RECEIVED
 CK'D BY: HKB OK'D BY:
 AUG 18 2008
 RESUBMIT APPROVED
 BY: RGS DATE: 8/25/08

NO.	DATE	REVISIONS	BY	123'-2" C/C BEARINGS	12'-0" CLEAR WALKWAY
1	7-9-08	CONNECTION DETAILS & BEARINGS	CRM	TOWN OF SWANTON	
2	8-12-08	REVISED PER REDLINE	CRM		
FRANKLIN COUNTY, VT					
DESIGN SCOTT		DRAWN. CRM		DATE 4-21-08	DRAWING NO 80691
CHECK/DATE		FABRICATOR US BRIDGE CORP		JOB NO 41217	SHEET 3 OF 4

① TRUSS BEARING PLATES

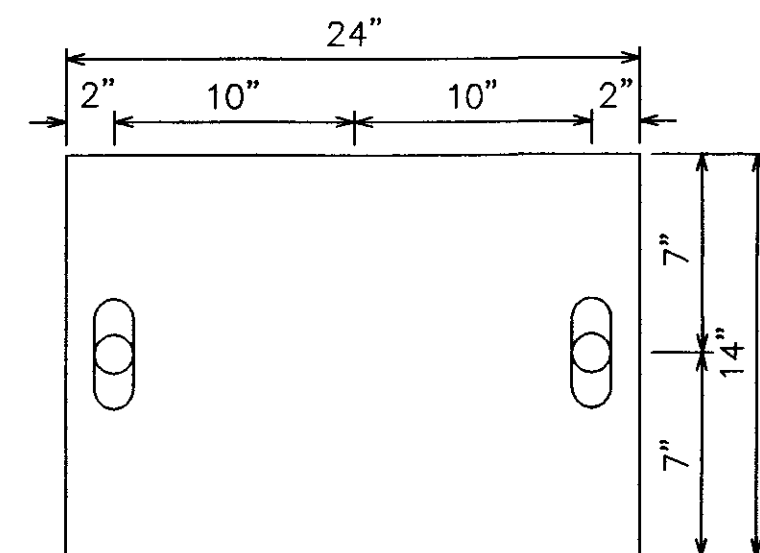
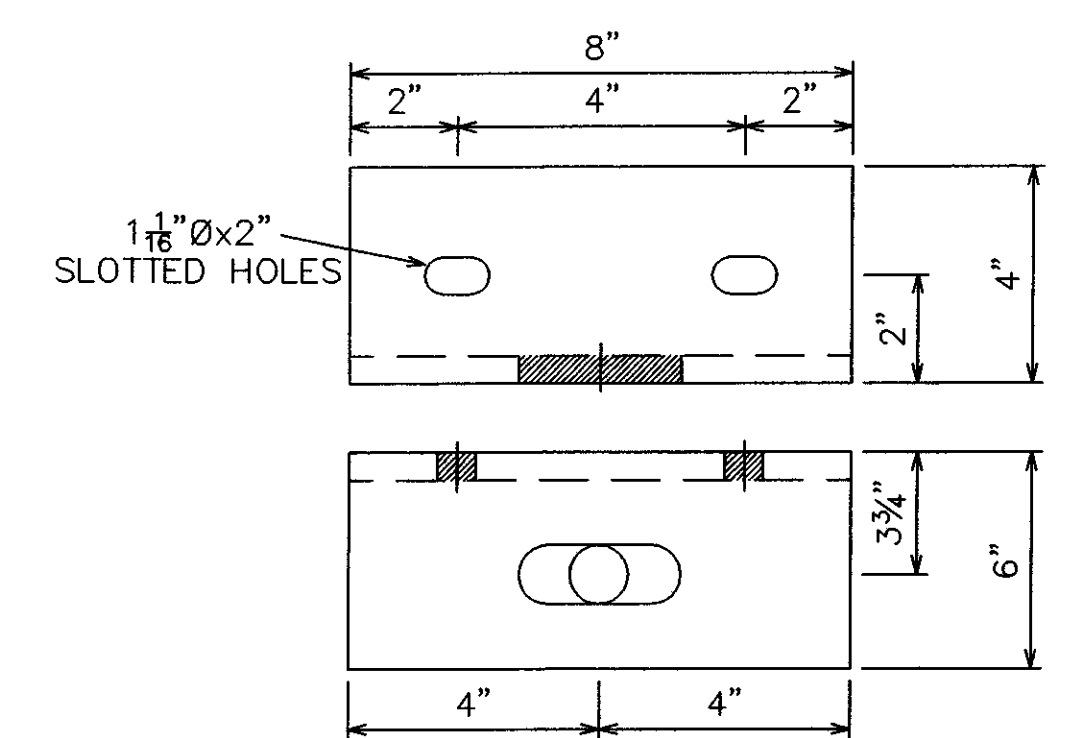
* PER LAST SUBMITTAL, AASHTO ROTATION CRITERIA WAS CITED, BUT TO COMPLY WITH VAOT STRUCTURE MANUAL, SECTION 23.15 AND FIGURE 23-3, PLEASE INCREASE BEARING THICKNESS TO 1 1/2".
